AUBURN HILLS 4TH ADDITION

WICHITA, SEDGWICK COUNTY, KANSAS

Re: S/D 97-42 - One-Step Preliminary-Final Plat of AUBURN HILLS 4TH ADDITION

CASE NUMBER: S/D 97-42 Auburn Hills 4th Addition

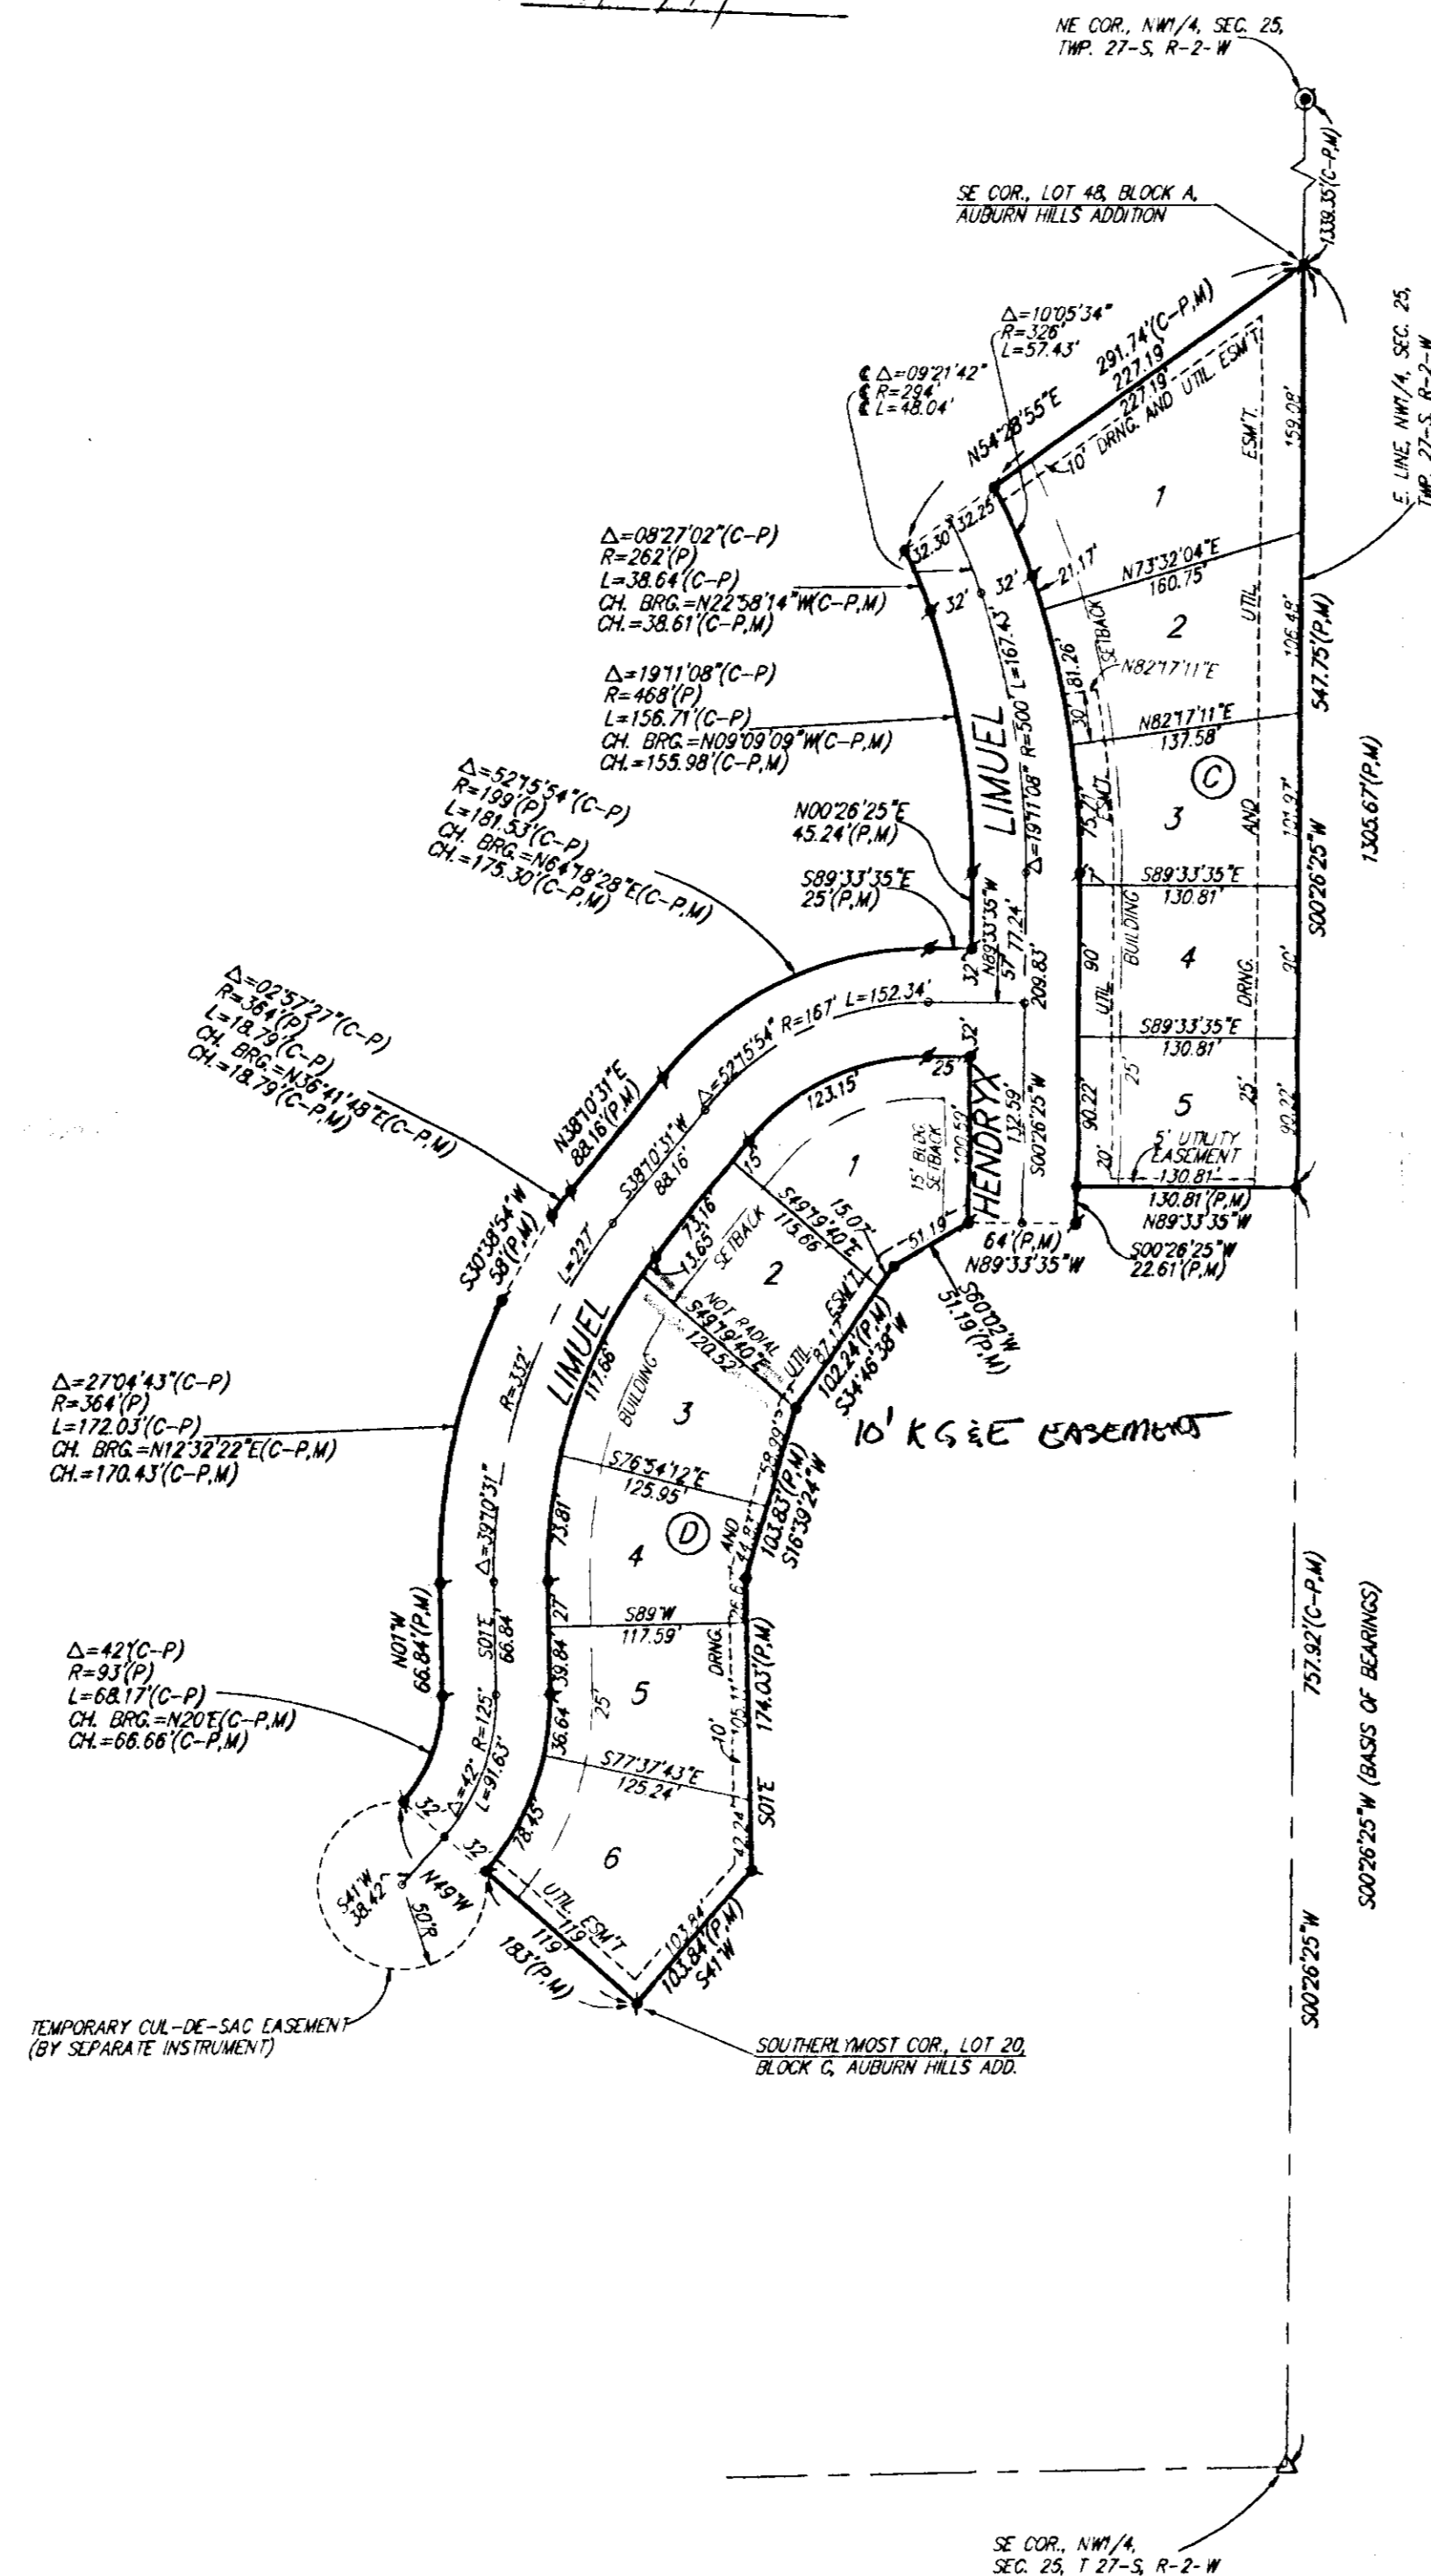
- A. **City Engineering** indicates the applicant's drainage plan is approved. The applicant shall guarantee the construction of any drainage improvements required by the platting of this property, including storm sewers.

- B. The applicant shall guarantee the installation of interior, residential streets.
- C. **City Engineering** indicates specials should be respread due to reduction from 13 Lots to 11 Lots.

- E. If additional, off-site utility easements are required along the west line of this plat, these easements shall be granted by separate instrument submitted with the final plat tracing.

- J. The representatives from the utility companies should be prepared to comment on the need for utility easements to be platted on this property. In the 2nd Addition, a utility easement was requested between Lots 4 and 5, Block B.

- K. Perimeter closure computations should be submitted with the final plat tracing.
- L. The applicant will provide utility easement requested.
- M. Appropriate departments have approved the proposed street name(s).

- N. Since this is a separate plat, the Blocks should be labeled "A" and "B" instead of "C" and "D".
